TRANS/WP.29/GRE/2005/21  
18 February 2005

PROPOSAL FOR DRAFT AMENDMENTS TO REGULATION No. 45  
(Headlamp cleaners)

Transmitted by the expert from the Working Party "Brussels 1952" (GTB)

For headlamps relevant to ECE Regulation No. 98 Class D or to ECE Regulation No. 112 Class A and B

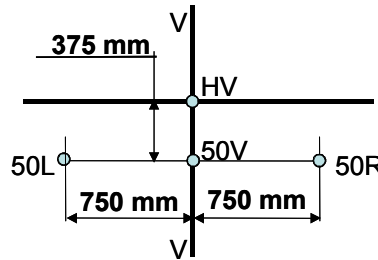
Paragraph 7.1., the diagram of measuring points on a screen, replace the existing diagram by:

With the introduction of the harmonized passing beam into UNECE Regulations Nos. 98 and 112 the positions of the photometric test points will change. This proposed amendment aligns the text of UNECE Regulation No. 45 to take account of the alternative test point positions in the case that a headlamp is producing the harmonized beam.
